HOMES NSW

29 FLORIDA STREET  
SYLVANIA (SSD-83258708)

RESPONSE TO SUBMISSIONS

REVISION 04

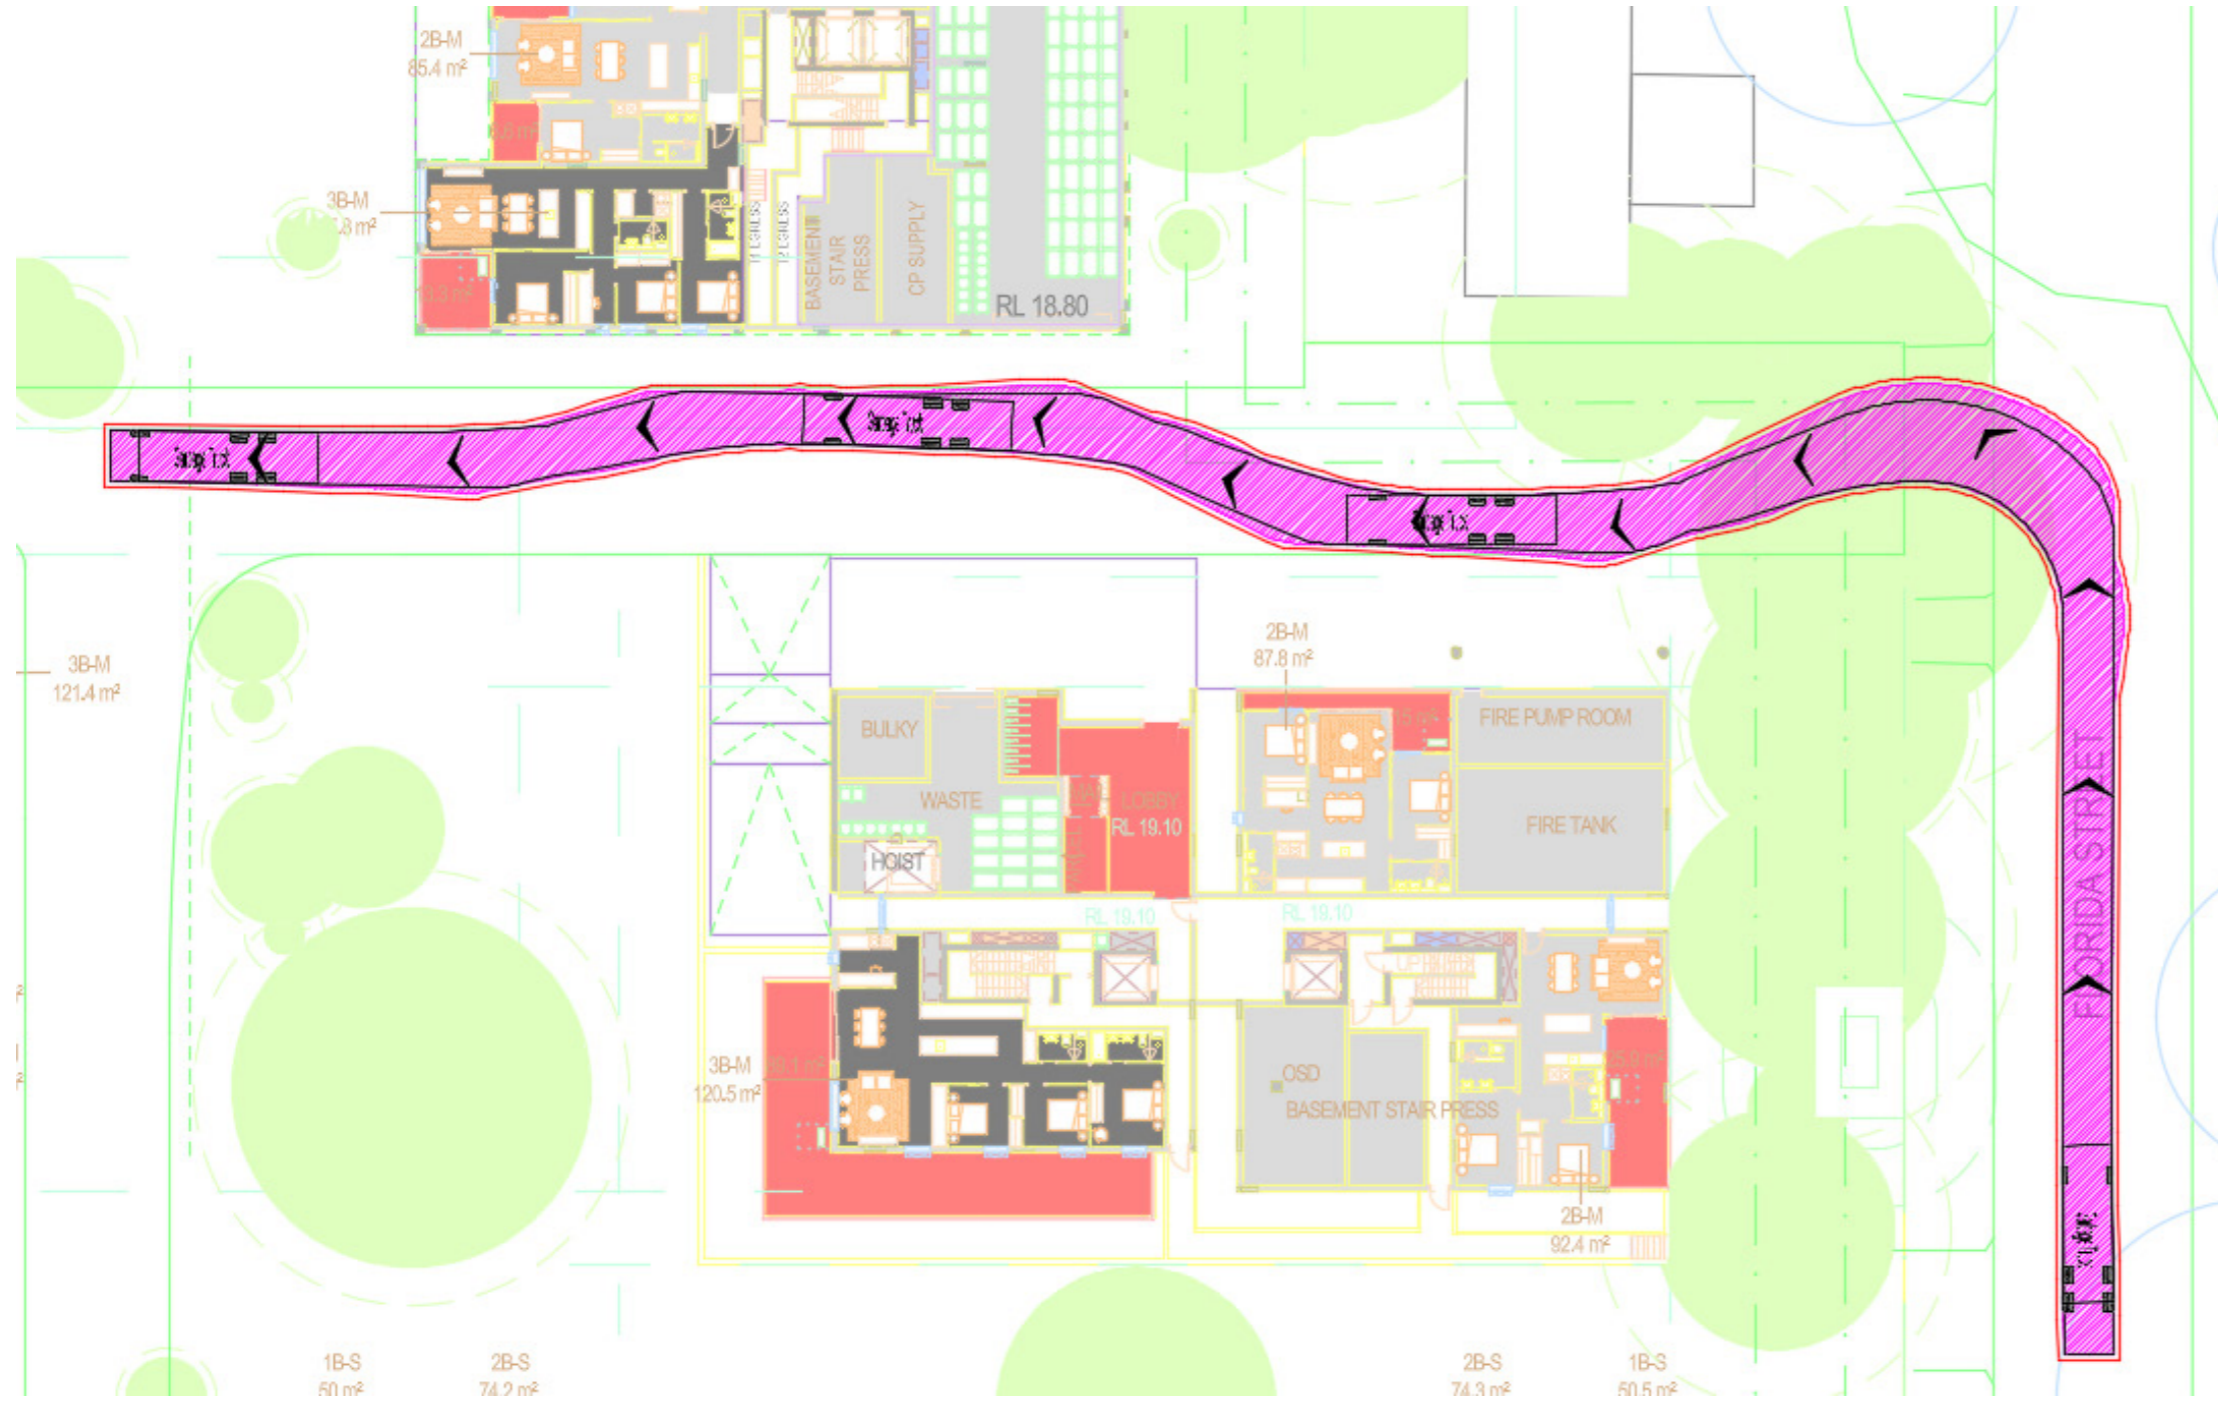
NO.	ISSUE RAISED	RESPONSE
<b>BUILT FORM &amp; URBAN DESIGN</b>		
7.1	As the proposal seeks to rely on Council's waste collection services, the waste servicing arrangements outlined in Council's submission dated 22 January 2026, along with Council's concerns with the design and function of the proposed internal road, must be addressed.	BVN have reviewed the proposed ground floor planning of Market Building 2 and coordinated with JMT Traffic and MRA Waste consultants to reduce the non compliant distances from waste room holding areas to waste vehicle parking on the internal road as reflected in the diagrams below. This will result in a minor re-plan of the lobby areas to the market building, and switching locations of the waste rooms with the 2bed on the other side of the lobby. As a result, waste vehicles servicing this building can park closer to Florida Street and, as indicated in the swept path, this will in turn shift the parking area for waste vehicles into Market building 3 closer to this waste holding area. Basement areas will also need a minor re-plan to coordinate hoist locations bringing waste bins up from the basement. Further clarification and detail has been provided as part of responses to submissions from waste and traffic consultants.

This diagram below has been prepared by JMT traffic reflecting the proposed parking locations for waste vehicles coming in from Florida Street

POTENTIAL LOCATION OF PEDESTRIAN VERTICAL CIRCULATION TO OVERPASS

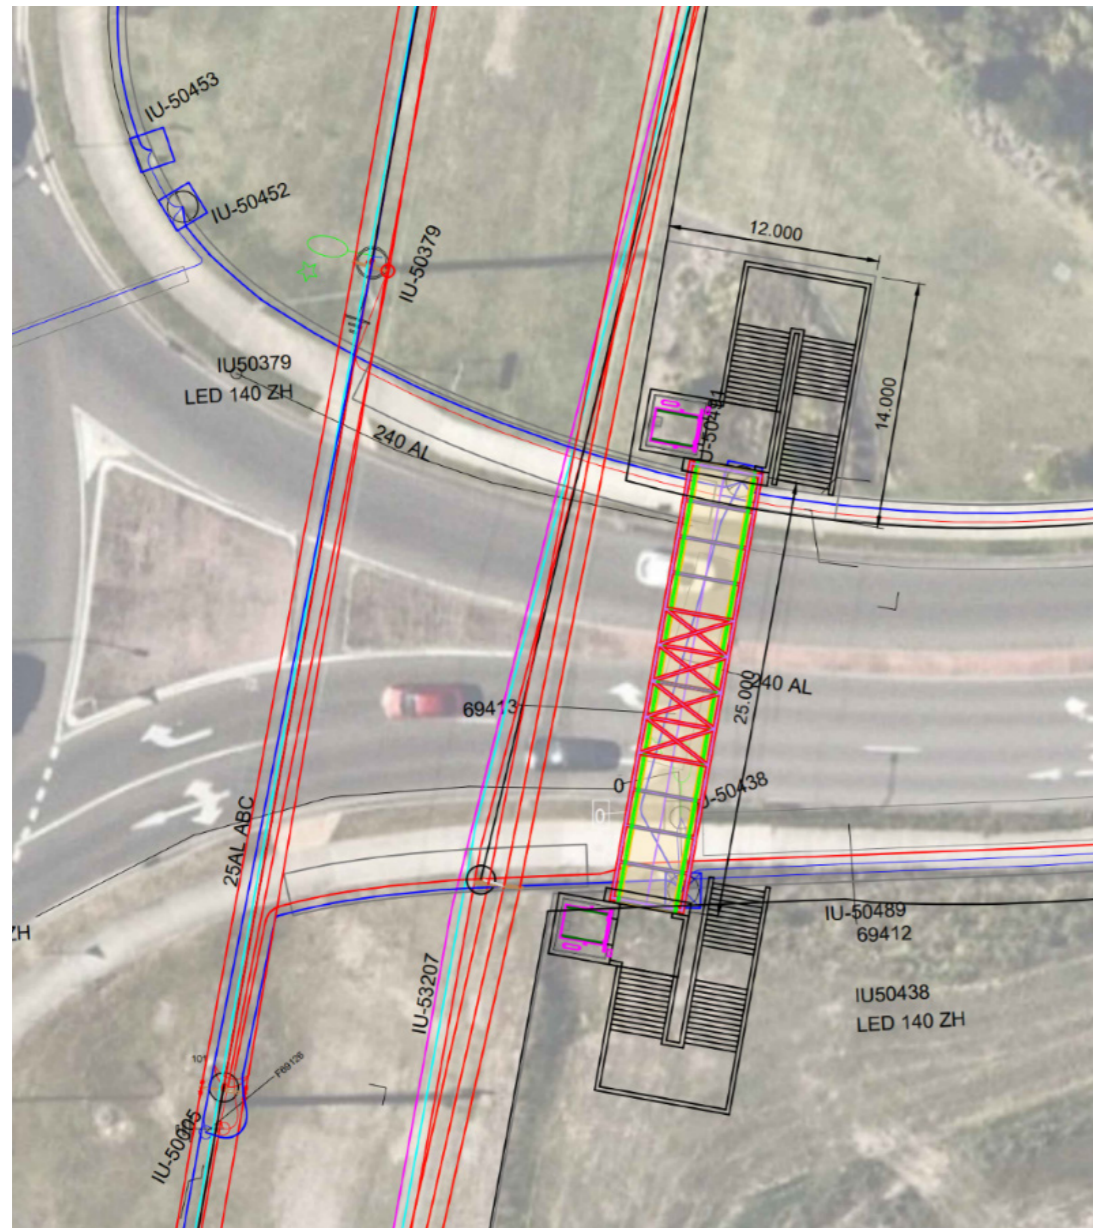
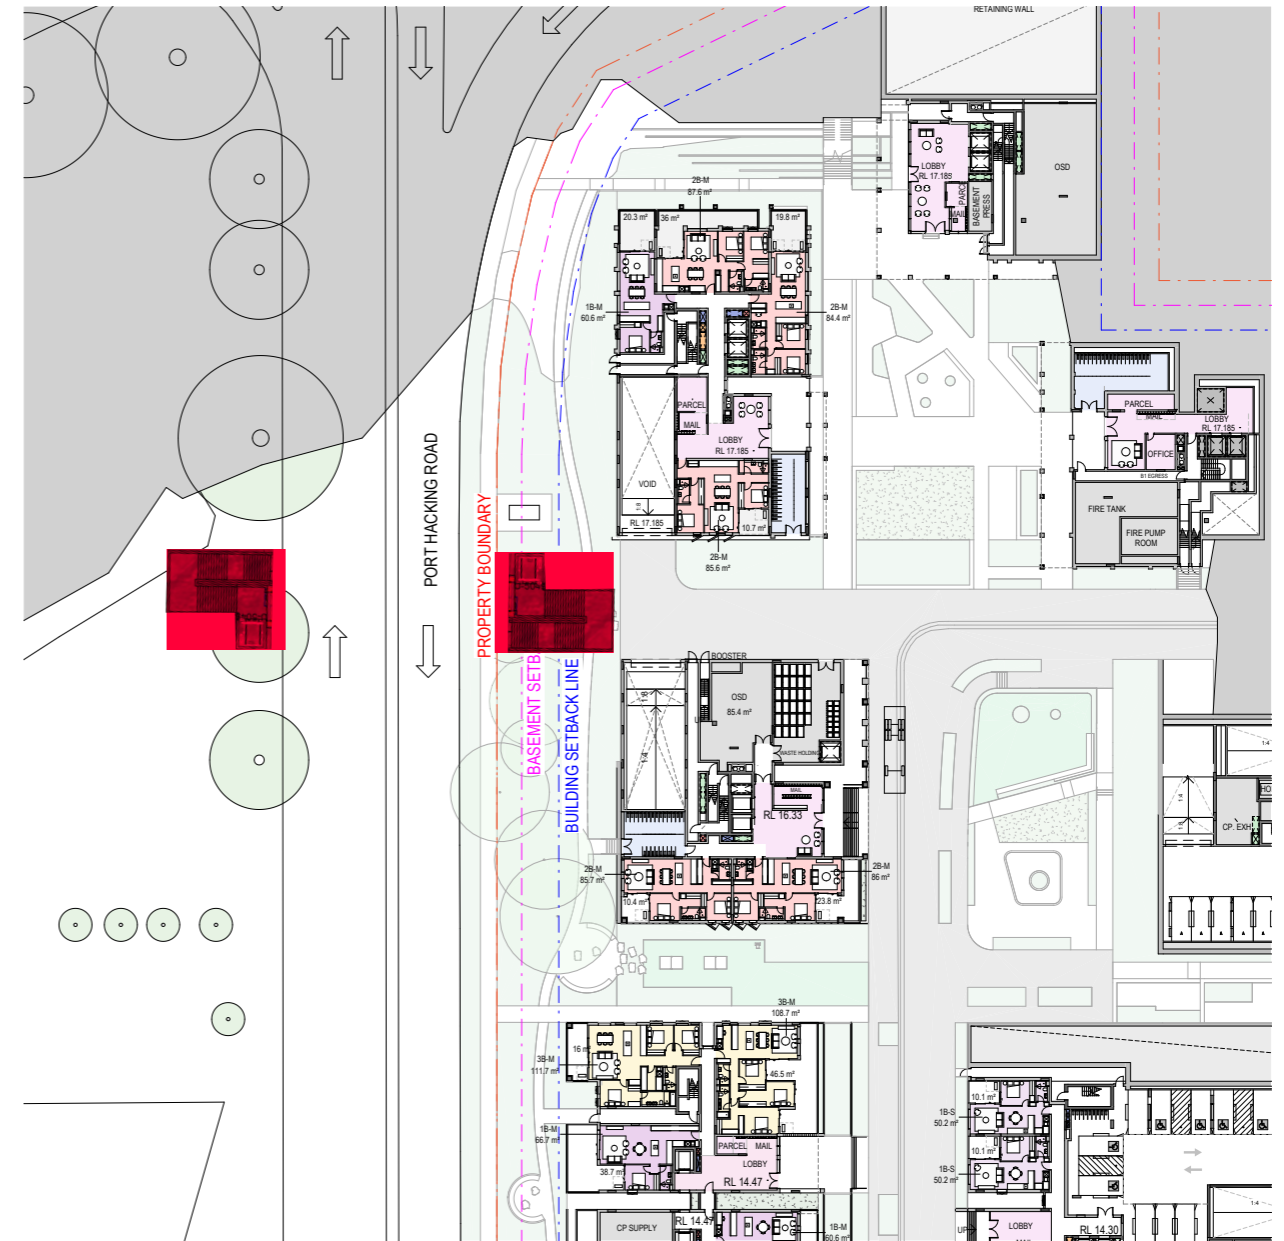
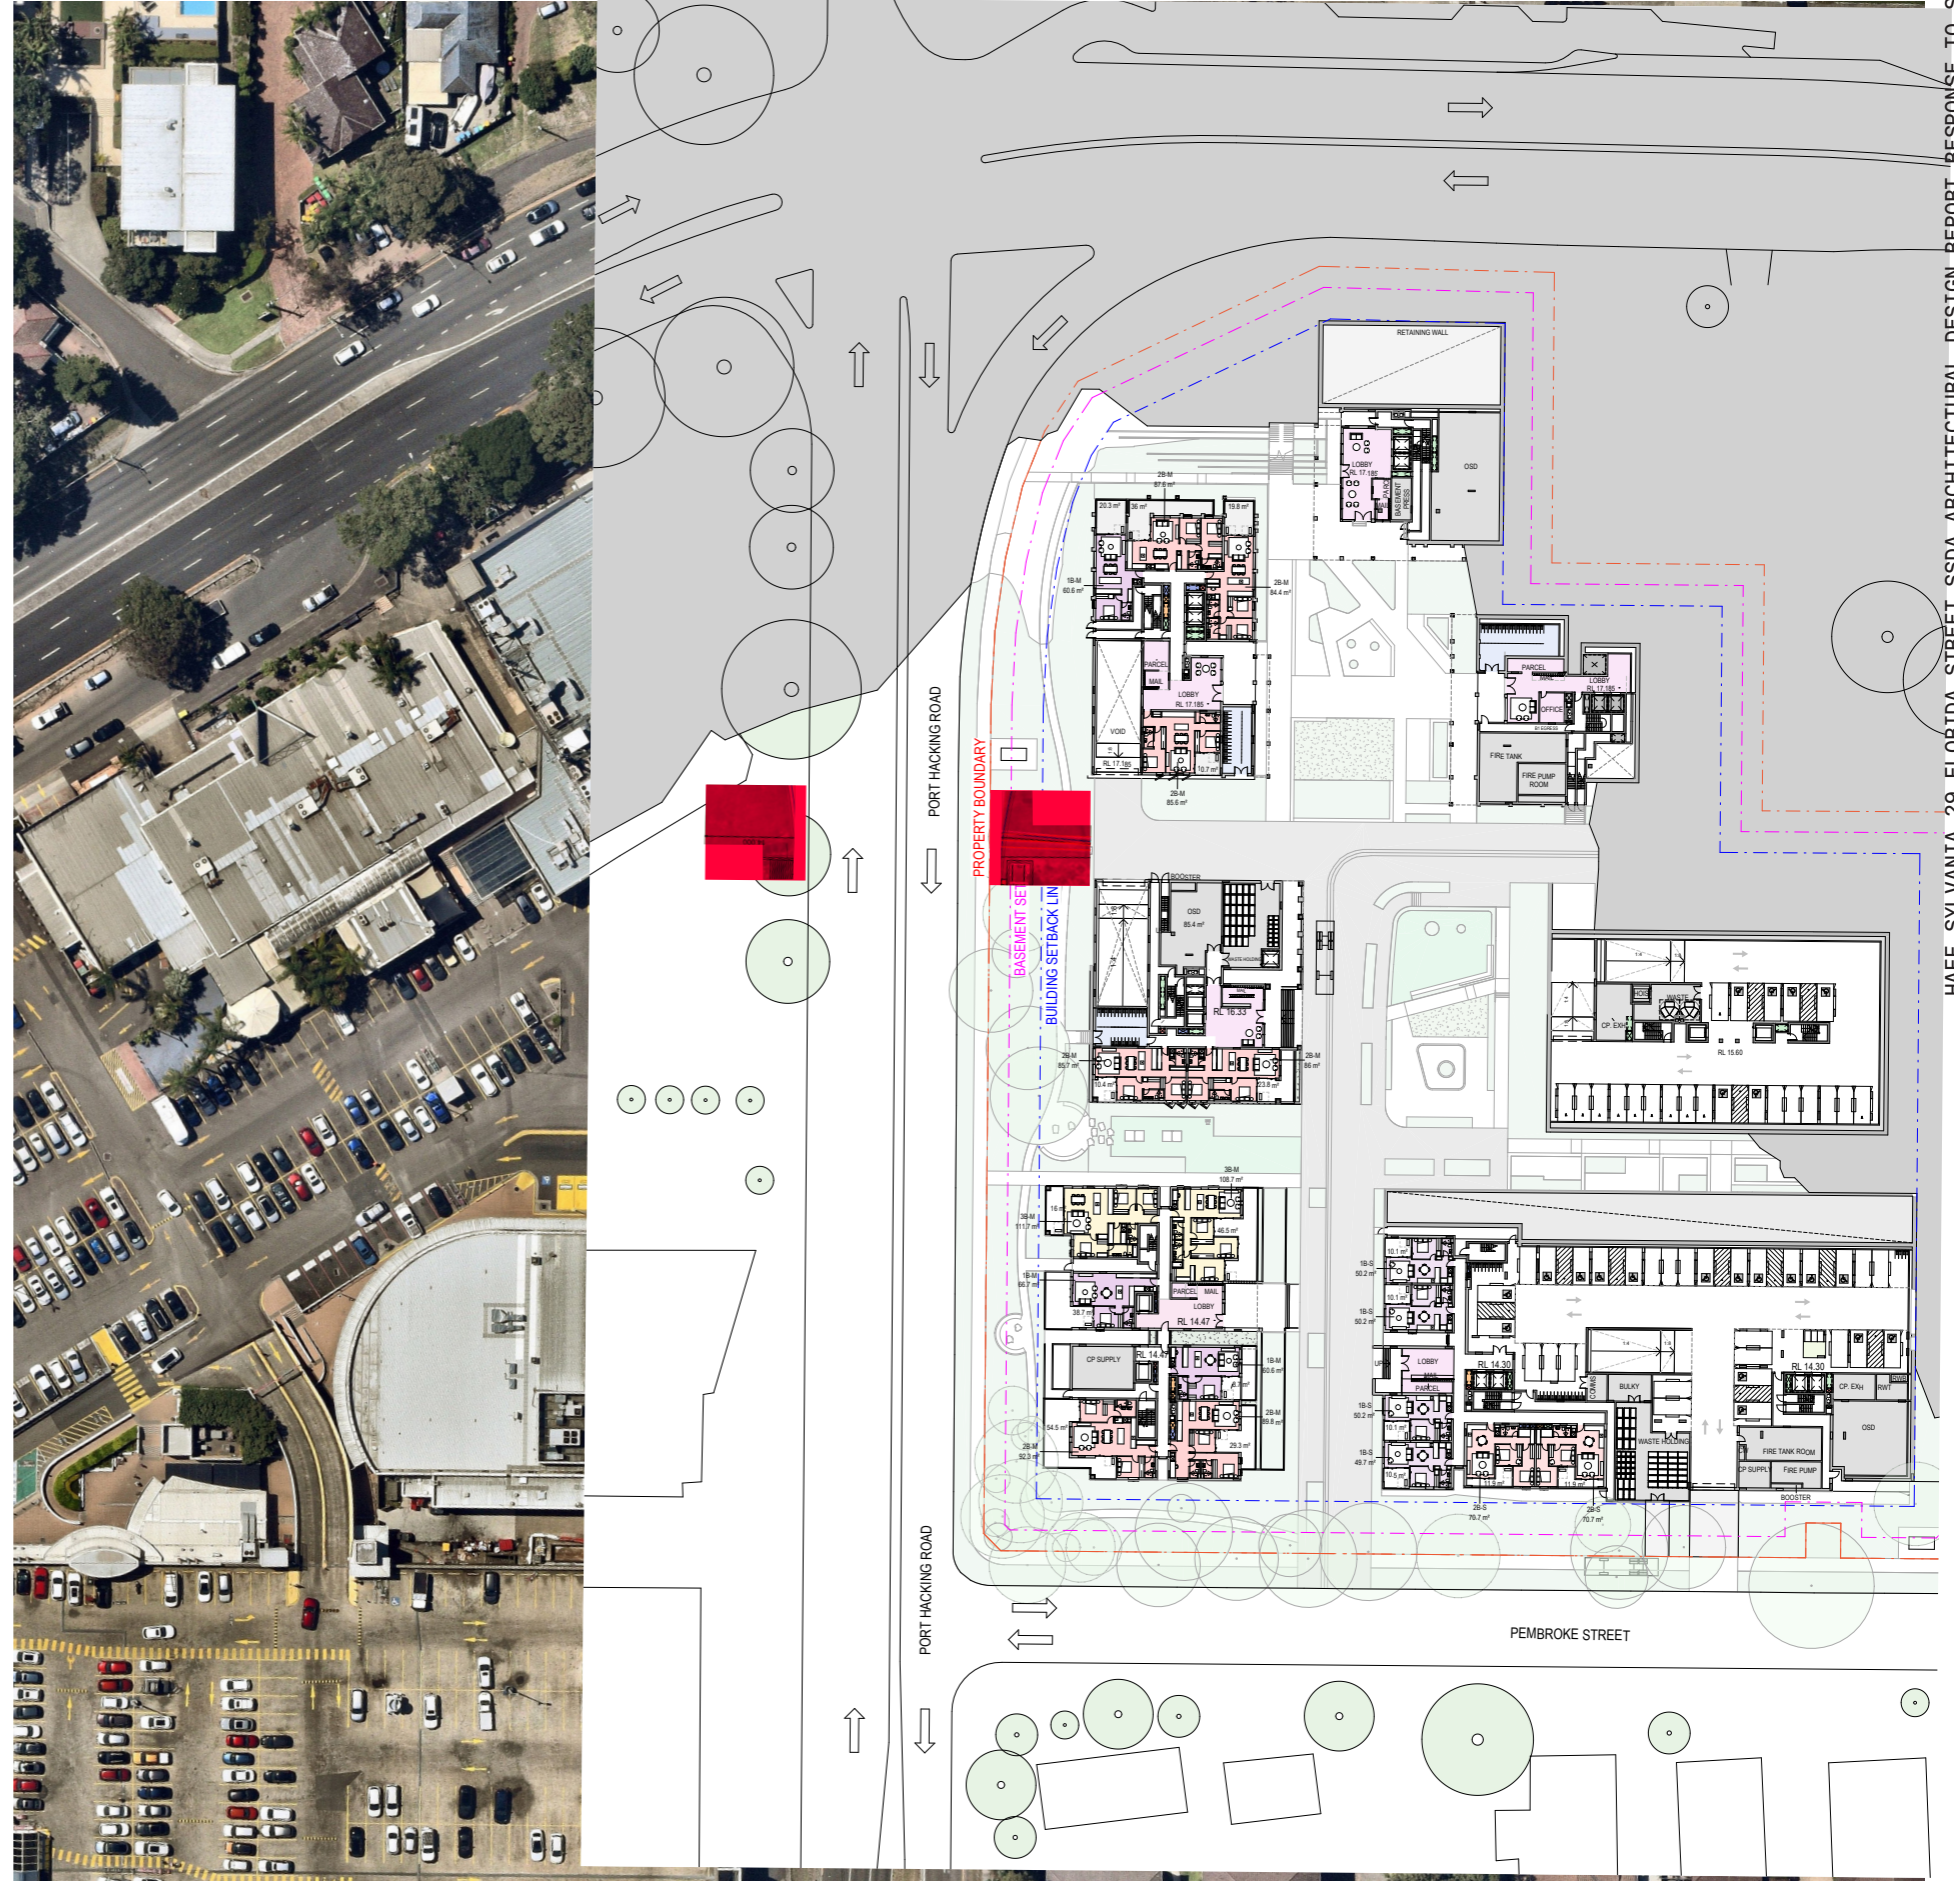
NO.	ISSUE RAISED	RESPONSE
<b>BUILT FORM &amp; URBAN DESIGN</b>		
7.2	Due to the extent of uplift proposed and improve pedestrian accessibility to Southgate Shopping Centre and public transport, TfNSW are to be consulted to consider the provision of pedestrian infrastructure upgrades to facilitate improved connections between the site and Southgate Shopping Centre	The inclusion of a pedestrian bridge across Port Hacking Drive as part of this submission has been assessed by both JMT traffic and HNSW and comes with significant complexity. The below diagram illustrates the optimal location and indicative size required to accommodate both a stair and lift (utilising a recently completed project to determine appropriate size and arrangement of the vertical circulation. This reflects the considerable limitation a new stair and lift configurations accessing the pedestrian bridge in the appropriate location along Port Hacking Drive will place on the development as well as the loss of significant trees.

HNSW have provided BVN with an example of a pedestrian overpass reflecting typical dimensions and requirements for lift and stair configurations. This does not equate to a design, or reflect the required stair heights and detail for any potential overpass over Port Hacking Drive.

The below diagram indicates the impact to the current proposal if a new stair and lift was to be incorporated.

The diagram (right) reflects the potential future impact to any development on Southgate Shopping Centre, noting this site is subject to future development
